# Response to submissions on the release of the 3.6 GHz band for wireless access services (WAS)

## Spectrum Planning Paper 6/09

OCTOBER 2009

Figure 2 Amended 3.6 GHz channel plan for the initial allocation

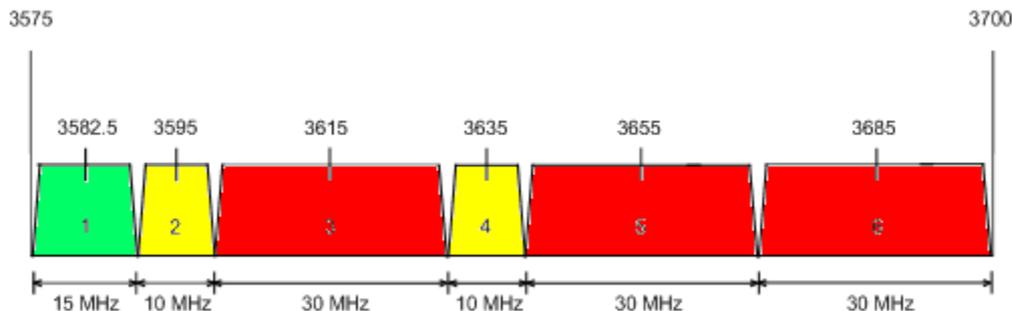
- > Eight respondents indicated support for the channel plan; three of these respondents suggested the ACMA consider amendments to allow a 30 MHz block to be made available.
- > Three respondents who agreed with the channel plan suggested amendments to allow for a 40 MHz block in the channel plan. The respondents cited reasons such as the future accommodation of emerging wireless technologies and to meet forecast growth and capacity demand.
- > One respondent commented that in areas where the spectrum is not fully utilised, free blocks should be left in between assignments to different operators in order to allow for future growth using contiguous spectrum lots.
- > One respondent suggested making use of channel polarisation in the channel plan to increase capacity re-use as part of the assignment model.

The ACMA has revised the channel plan to include larger 30 MHz block options as a result of the policy decision to implement a 30 MHz maximum available bandwidth per licensee. This channel plan is intended to be used for the initial allocation period only; once all areas of regional and remote Australia have been released, the ACMA will

The revised channel plan aligns with the current 3.8 GHz fixed link channel plan. Alignment between the two channel plans will eliminate inter-channel overlap; minimise the impact each deployment will have with existing licences and maximise overall spectrum availability.

The revised channel plan also includes 10 MHz spacing between the larger 15 MHz and 30 MHz blocks. Where demand is low in geographic areas, these 10 MHz blocks may not be allocated. These unallocated blocks will effectively act as a guard band between the larger blocks, providing greater protection for licensees while facilitating future growth of capacity in contiguous spectrum lots. The revised channel plan can be seen in Figure 2 below.
